**NSLPP MEETING HELD ON 04/12/2024****Attachments:**

ADDRESS/WARD: 42 & 42A Milson Road, Cremorne Point**APPLICATION NO:** RD 10/24 (DA302/23)**PROPOSAL:** S8.2 Review of Determination of DA 302/23 seeking approval for alterations and additions to lower ground, ground level and first floor additions and demolition of garage and replacement with a two (2) car garage with green roof.**PLANS REF:**

OWNER: Amrit Pal Singh & Harpreet Kaur**APPLICANT:** Michael Briscas**AUTHOR:** Report of Michael Hornery, Executive Assessment Planner**DATE OF REPORT:** 29 October 2024**DATE LODGED:** 24 July 2024**DATE AMENDED:** 23 September 2024**RECOMMENDATION:** Approval

Figure 21: Section of building showing the 8.5m maximum height limit, existing building outline and proposed building outline Plan 404 Rev D (Source: Quattro Architecture).

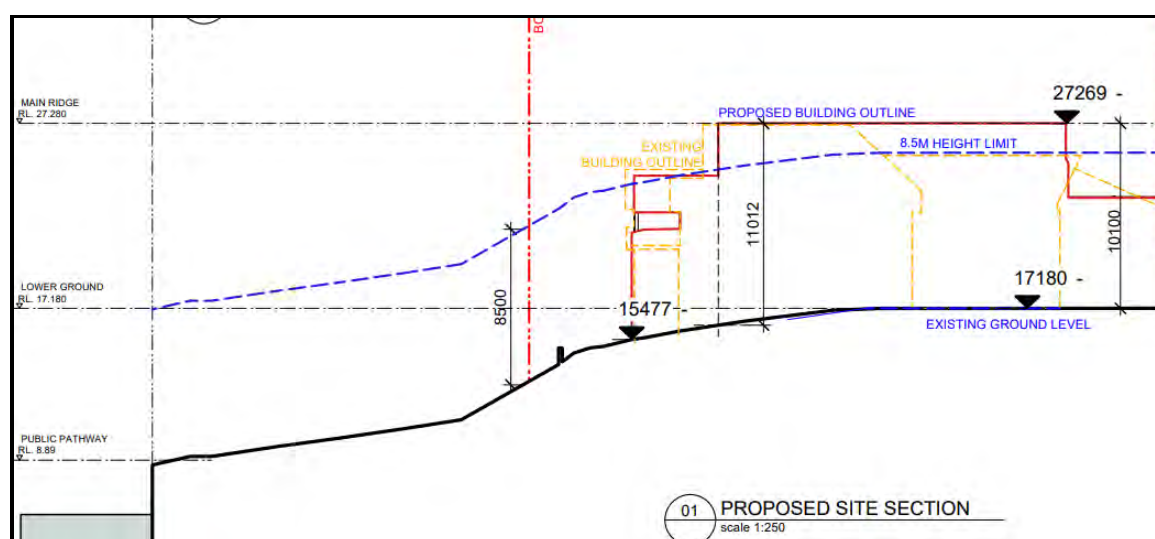
The proposed development seeks a variation to the development standard relating to height (Clause 4.3). The NSLEP identifies a maximum height control of 8.5m. The building is proposed to be 11.012m in height which exceeds the maximum building height by 2.512m, a variation of 29.6% to the development standard.

Any variation to a statutory control can only be considered under Clause 4.6 – Exceptions to Development Standards of the NSLEP. An assessment of the proposed height against the survey plan levels was conducted to indicate the Applicant’s calculations are generally accurate.

<p>Figures 29 & 30 – Floor Plan of Garage, Common Entry and Front Elevation of proposed 3 car garage under the original development application (DA302/23).</p>
--	--	---

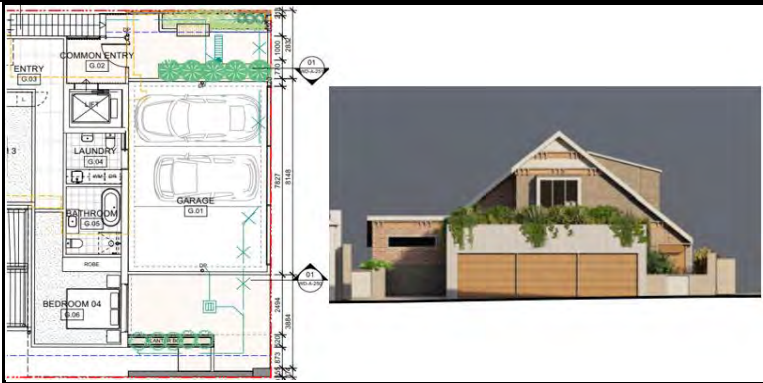
1.5.4 Vehicle Access and Parking	Yes	<p>The existing garage comprises of a large four (4) car parking area to the front of the site. The garage is to be demolished and replaced with a two (2) car garage with flat/green roof, which is a further reduction in width from the original DA.</p> <p>The reduction in the size of the garage and provision of landscaping is considered an improved built form outcome reducing the bulk and scale compared to the existing garage.</p>  <p>Figure 28 – Photo of existing four car garage which extends to the width of the site</p>
---	-----	--

<p>Figures 31 & 32 – Amended plans submitted with S8.2 application showing floor plan of proposed 2 car garage, additional landscaping, common entry and front elevation.</p>
--	--	---

Figure 33 –Site area calculation plan showing the existing and proposed site coverage, unbuilt upon area and landscaped area.

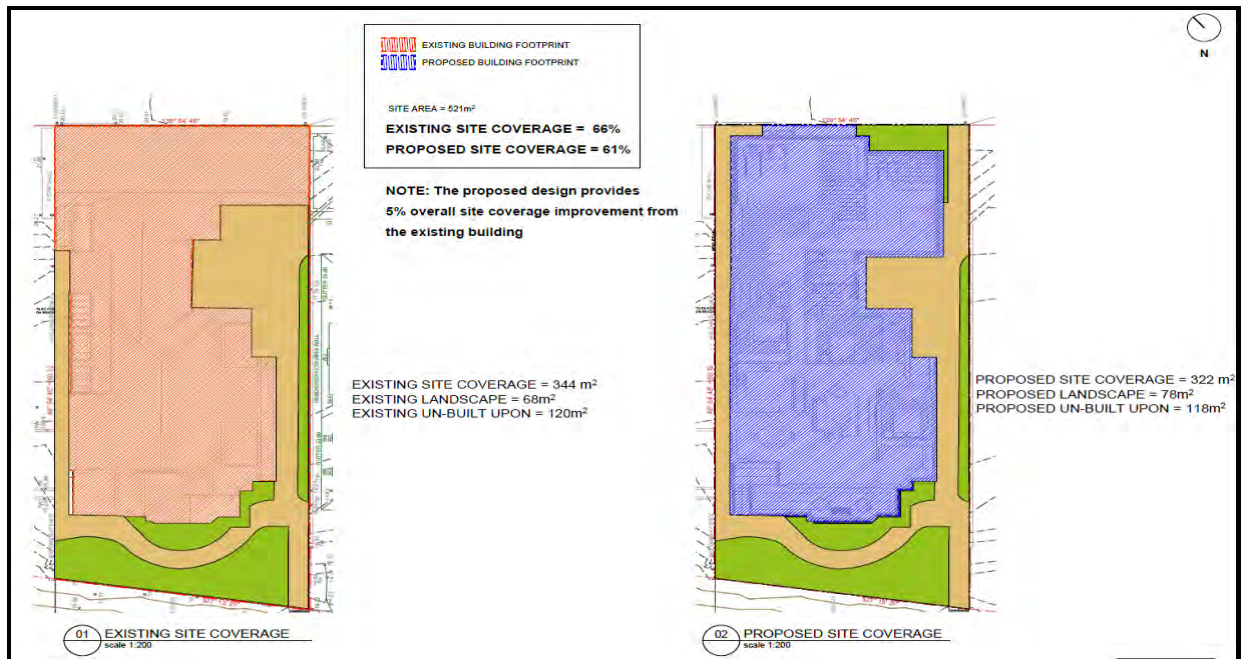
<p>1.5.5 Site Coverage</p>	<p>No, however acceptable on merit</p>	<p>The proposed development is subject to a maximum site coverage of 45% (234.41m²). A site coverage calculation diagram is submitted as part of the architectural plans confirming the existing site coverage at 344m² (66%) and the proposed site coverage at 322m² (61.8%).</p>
-----------------------------------	--	---

Whilst the site coverage is non-compliant, the proposal does result in a net reduction in site coverage, to ensure an improved site coverage outcome to control site density and limit the building footprint to ensure a development more commensurate to its Low Density Residential Zoning.
